ERRORS FOUND IN THE CORVAIR SHOP MANUALS

Edited by Bob Helt with help from Kent Sullivan and others

The following items are errors that we have been able to find in the Chevrolet issued **Corvaair Shop Manuals**. Many of these errors are trivial or simply typos, but in the interest of thoroughness, I have included them too. In addition I have found many omissions in these manuals and these are also listed. Sometimes the omissions are more important than the actual errors. This is, unfortunately, not a complete list since many unnoticed errors still exist. But let's consider it a start. Additions and corrections are welcomed. Contact me at Bobhelt@aol.com

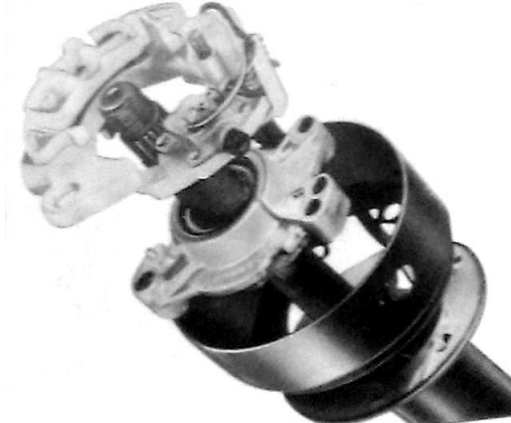
41	8-28,29	Omission	heater motor circuit is missing on
